# Proposal for Timestamping with AM, CWM, and Idle Rate Adaptation

IEEE 802.3cx Teleconference Sept 23, 2020

Figure 90-1—Relationship of the TimeSync Client, TSSI and gRS sublayer relative to MAC and MAC Client and associated interfaces

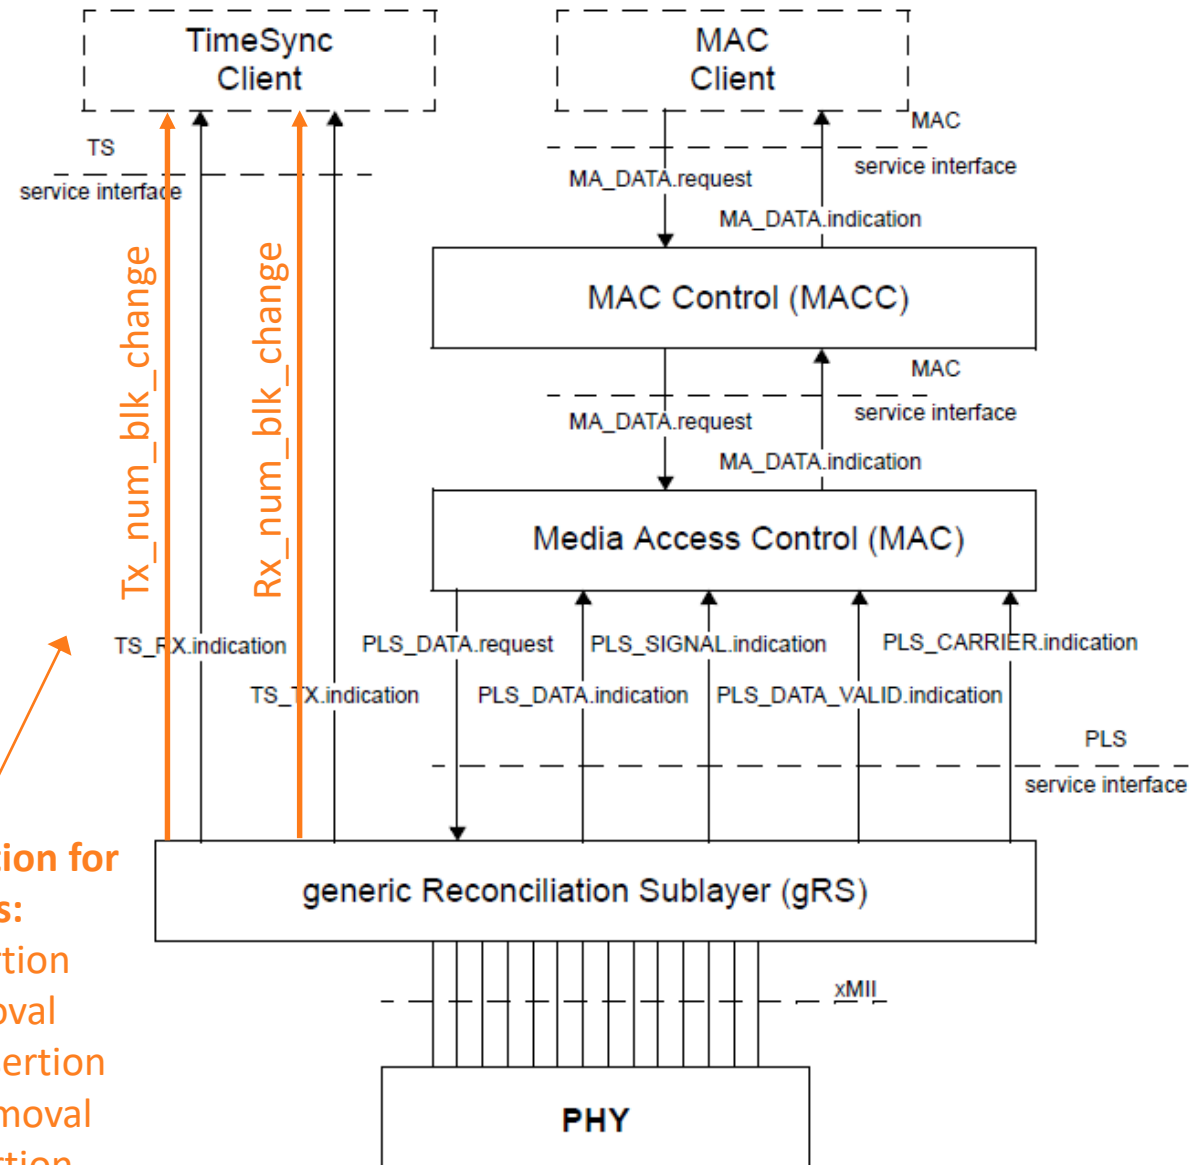
## • Update Figure 90-1

- Add signals that allow the Time Sync Client to adjust its timestamps for AM or CWM insertion/removal and the corresponding Idle removal/insertion
- For TS\_TX indications, the signal indicates how many blocks will be removed (Idles) or inserted (AM, CWM) and affect the transit delay of PTP message timestamp points through the Tx PHY
- For TS\_RX indications, the signal indicates how many blocks were removed (AM, CWM) or inserted (Idles) and affected the transit delay of PTP message timestamp points through the Rx PHY

Another option for these signals:

- AM insertion
- AM removal
- CWM insertion
- CWM removal
- Idle insertion
- Idle removal

Figure 90-2—TS\_SFD\_Detect\_TX and TS\_SFD\_Detect\_RX functions within the generic Reconciliation Sublayer (gRS)

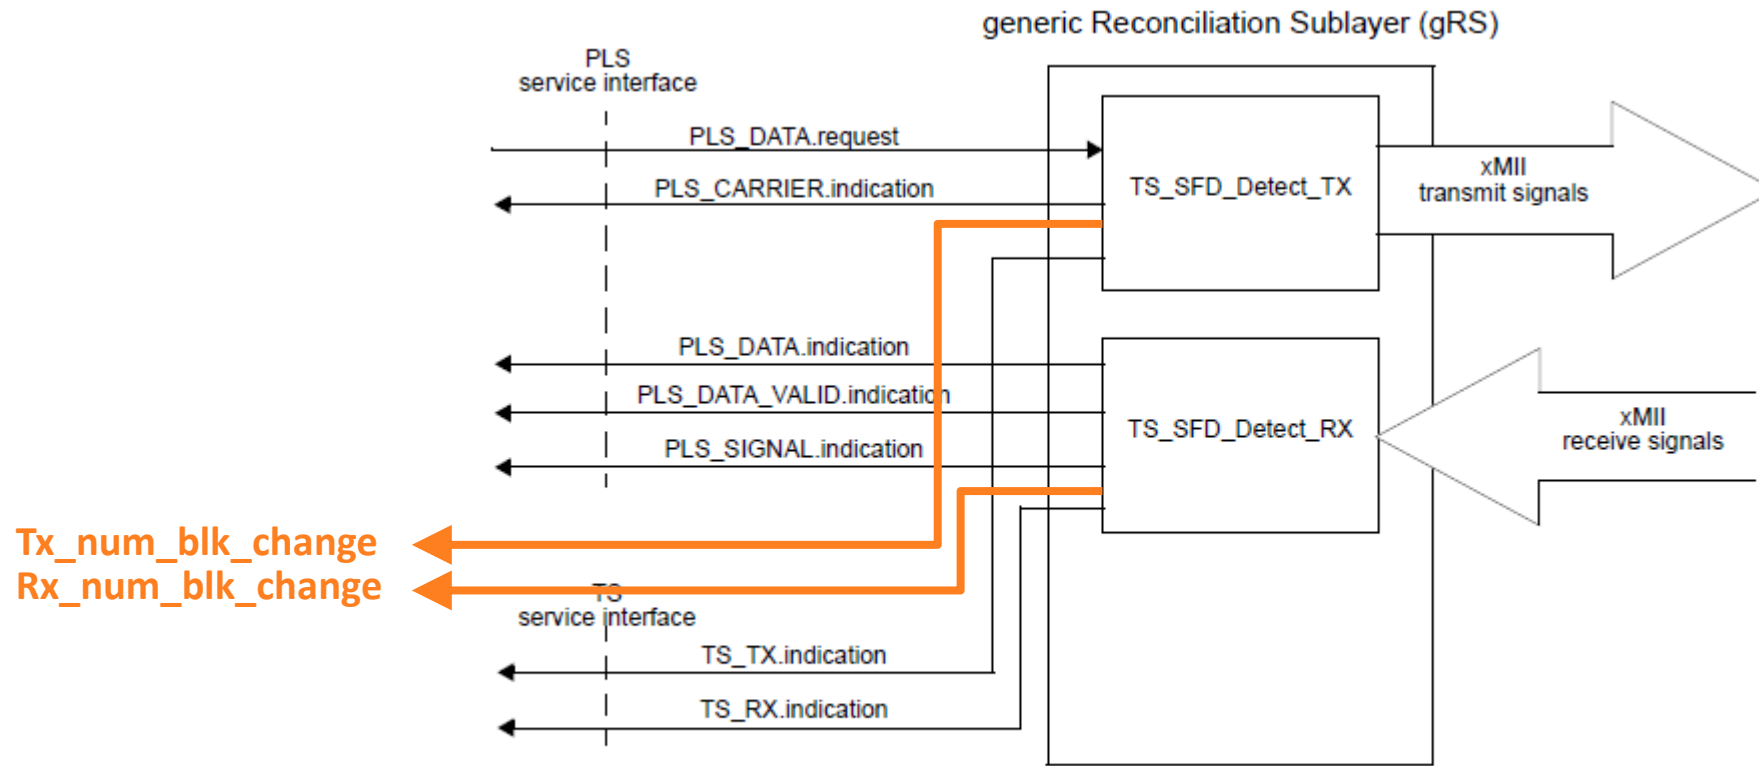
- Update Figure 90-2
  - Add the same signals to the gRS figure
